Amend section 13 of Council Bill 117603 to lower the proposed base Floor Area Ratio (FAR) for commercial development in the SM 160/85-240 from 4.5 FAR to 4 FAR. Amendments are shown in track changes.

Amendment 3 – Affordability Levels for Income Eligible Households Sponsor: Licata

Amendment 4 – Sunset Date for Residential In-lieu Payment in South Lake Union Sponsor: Licata Pink

Amendment 5 – Consent Items Sponsor: South Lake Union Special Committee Green

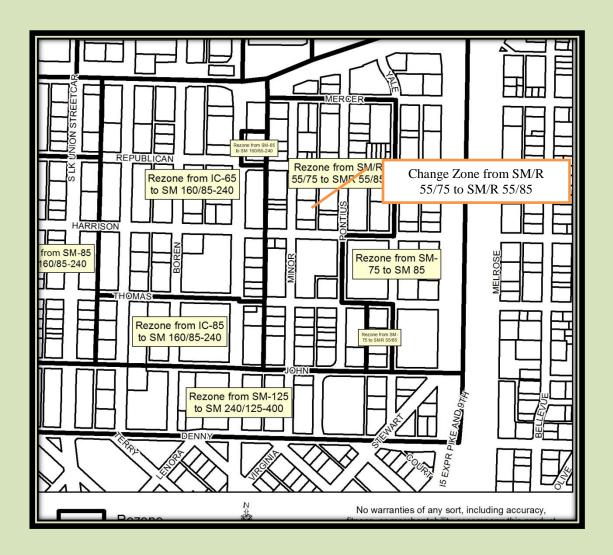
C) Amend exhibit A of Section 1 of Council Bill 117603 to rezone portions of the Cascade Neighborhood from Seattle Mixed / Residential with a 55 foot height limit for commercial development and a 75 foot height limit for residential and mixed use development (SM/R 55/75) to Seattle Mixed / Residential with a 55 foot height limit for commercial development and a 85 foot height limit for residential and mixed use development (SM/R 55/85).

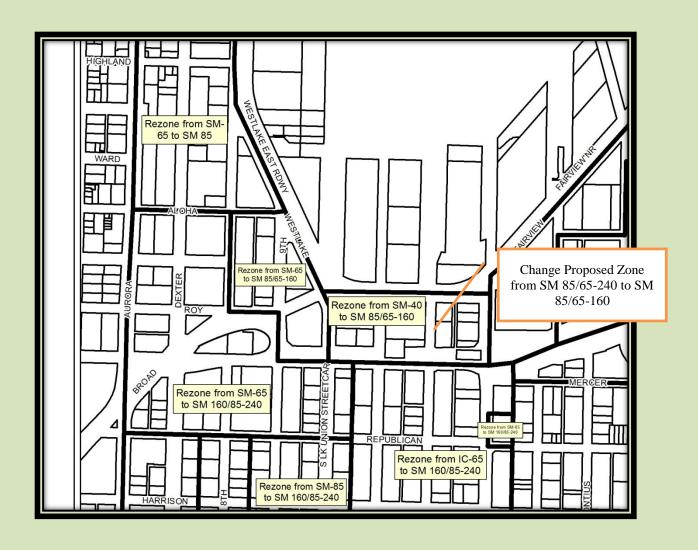
D) Amend exhibit A of Section 1 of Council Bill 117603 to change the proposed zone designation for the Blocks bounded by Mercer, Fairview, Valley and Westlake (Mercer Blocks) from SM 85/65-240 to SM 85/65-160 and amend Section 14 of Council Bill 117603 to eliminate the authority to allow higher heights if approved through a development agreement. Amendments to the text are shown in track changes.

E. Additional height for provision of affordable housing within the South Lake Union

Urban Center. A lot in the SM 85/65-240 zone may add floor area above 160 feet up to 240 feet
